Subject: Rice Solar Energy Project (09-AFC-10)
Response to CEC Workshop Queries 4, 6-8, and 11

Responses to CEC Staff Workshop Queries 4, 6-8 and 11

Rice Solar Energy Project

(09-AFC-10)

**FIGURE WSQ4-1
OPERATIONS PHASE
PERMANENT FENCELINE**
Rice Solar Energy Project
Riverside County, California

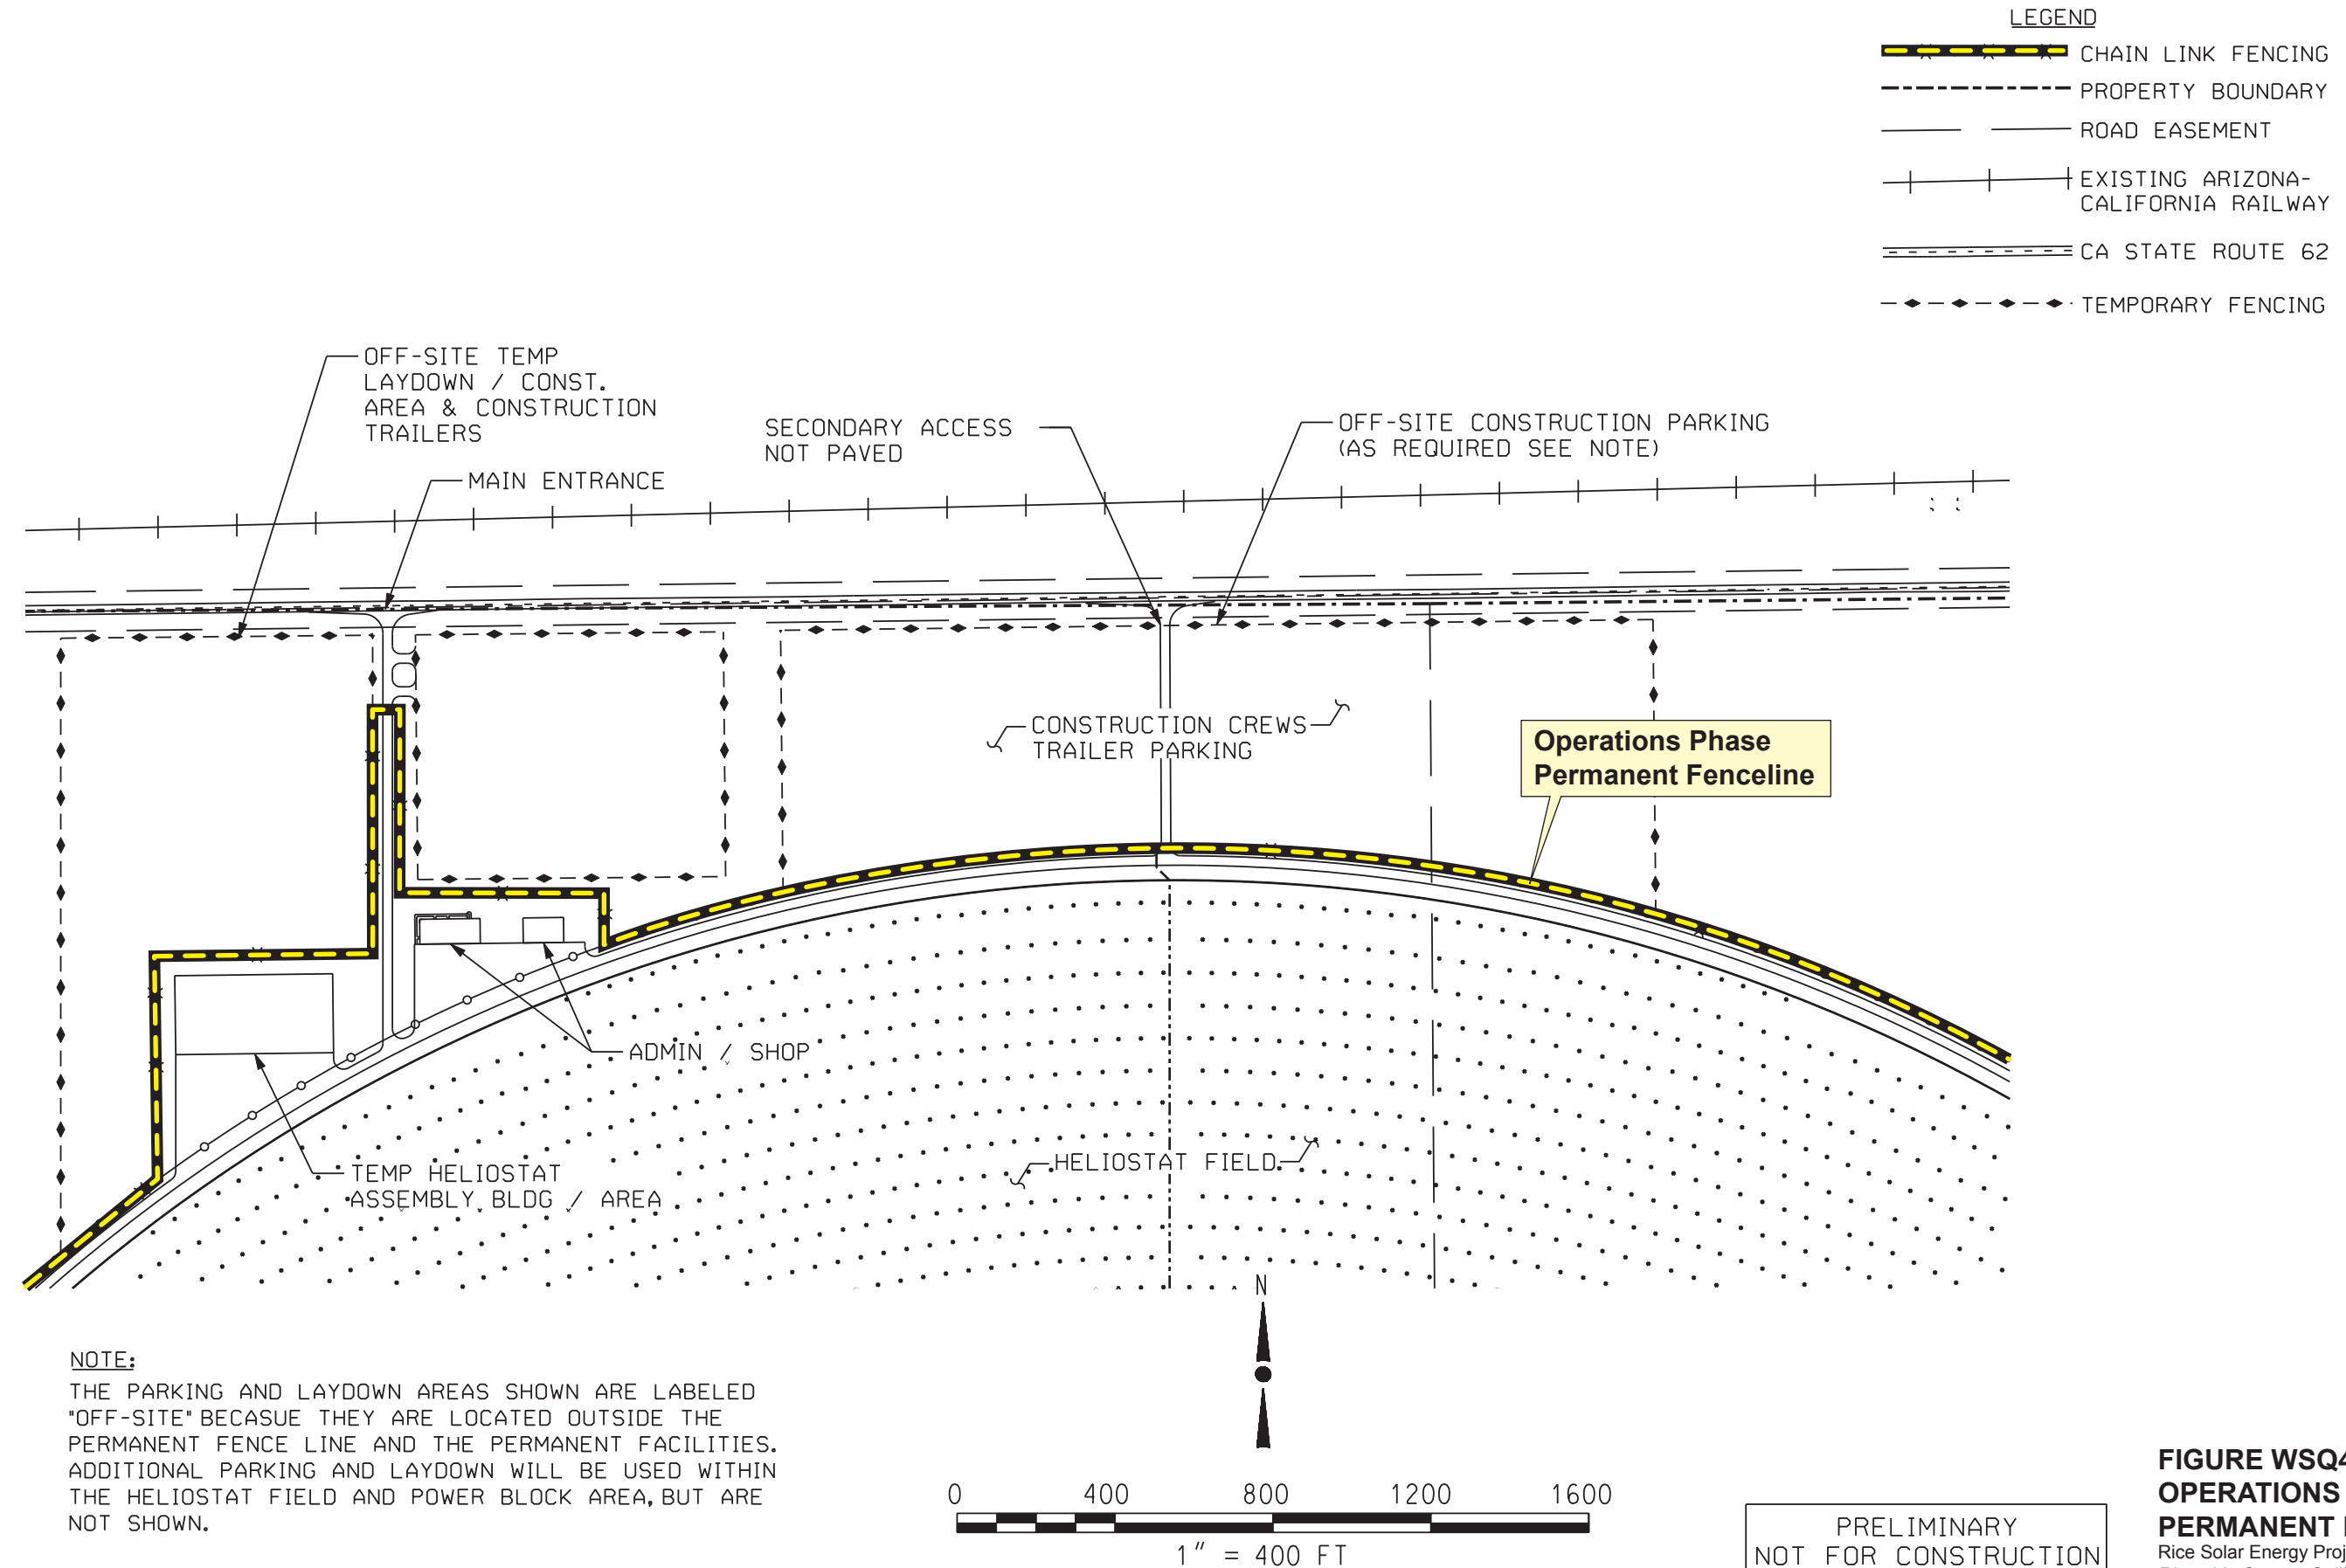
WSQ 4 Please provide an illustration that shows the fenced area during the operations phase of the project, at the north end of the heliostat field (as opposed to the fenced area during construction).

Response: During construction, the fenced area at the north end of the heliostat field will include the administration and shop building, heliostat assembly building, worker parking, worker residence (trailer park), and construction laydown areas. Once construction has been completed, this fenced area will shrink by approximately 94 acres. The total fenced area including the heliostat field will be reduced from 1,504 to 1,410 acres. The fenced area during operations will contain only a fenced access roadway connecting the heliostat field with State Route 62, the administration/shop building, and the heliostat assembly building. The construction laydown and worker parking areas will no longer be used and will be outside of the permanent fence. This is illustrated in Figure WSQ4-1.

SEPTIC SYSTEM A LAYOUT

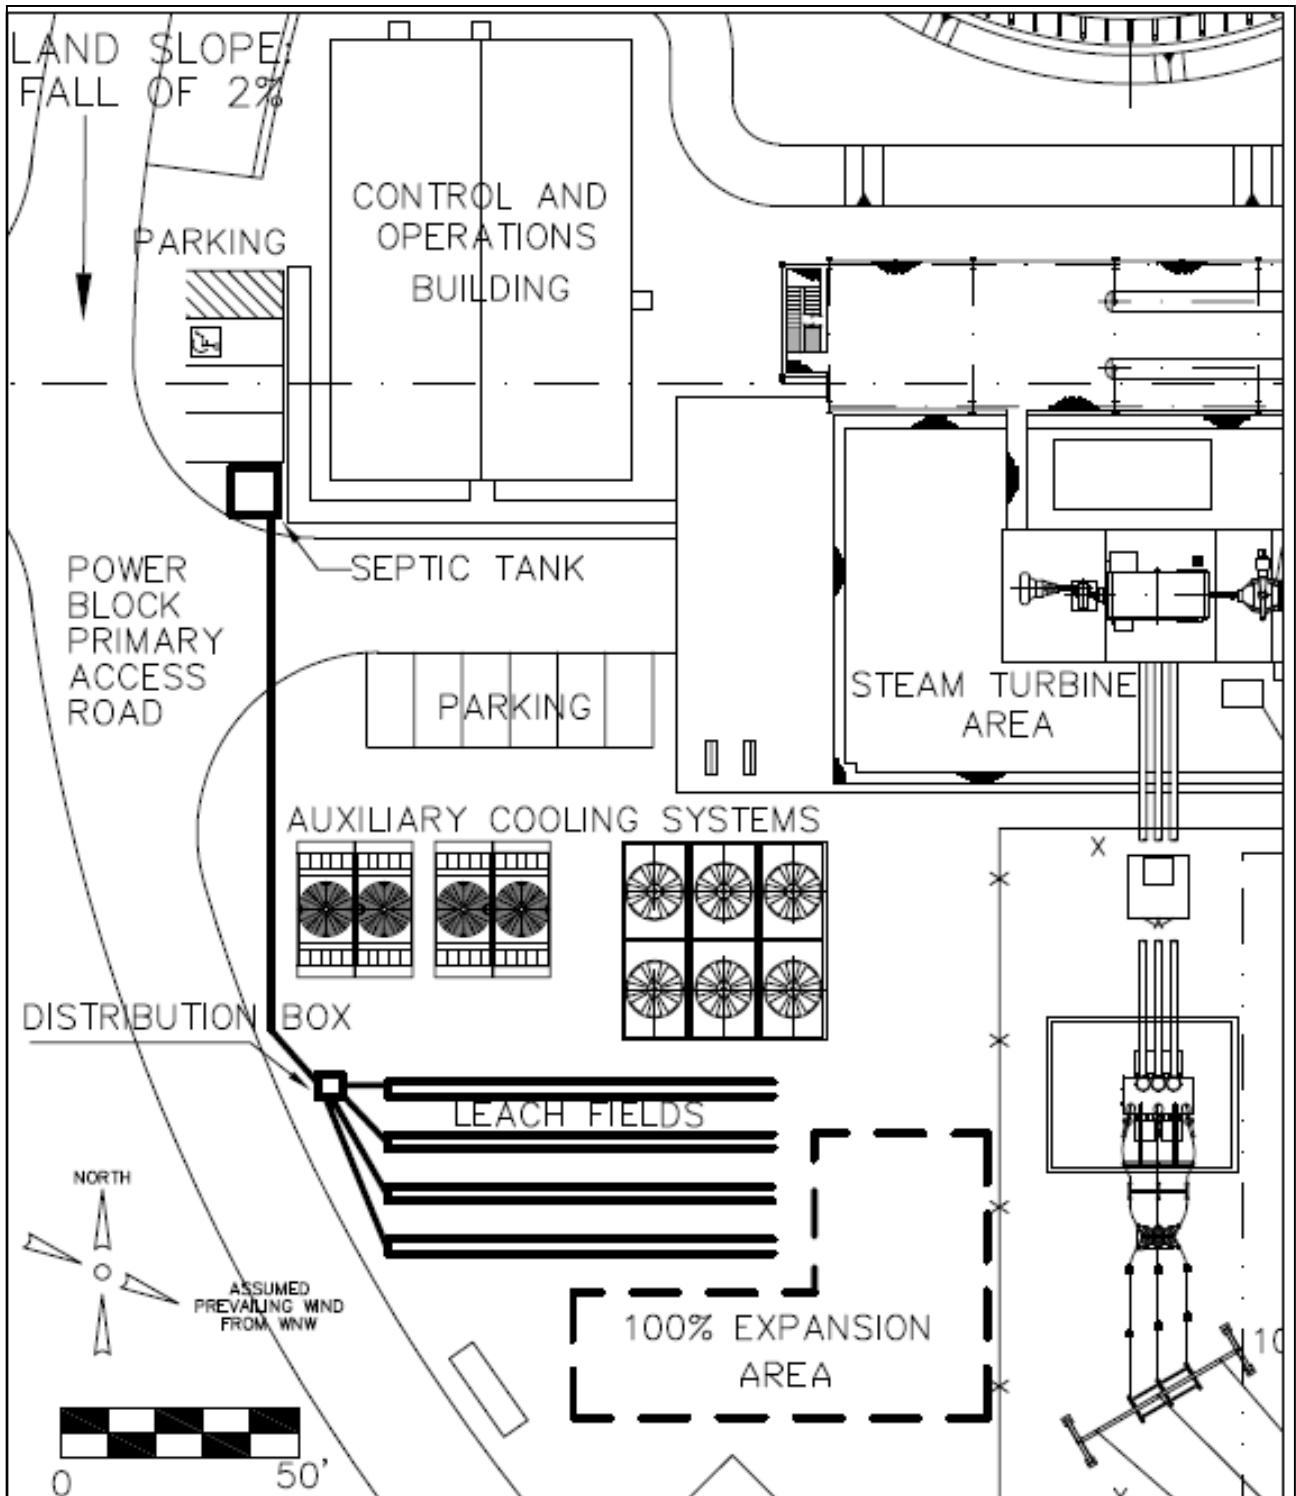
WSQ 8 Please provide additional information on the design of the septic system.

In addition, all OWTS require an area designated that could be used for 100% expansion of the original system. An expansion area has been allocated on **Figure 3 and 4**, however this area would also require percolation testing to determine if the rate is acceptable for locating the 100% expansion disposal field.
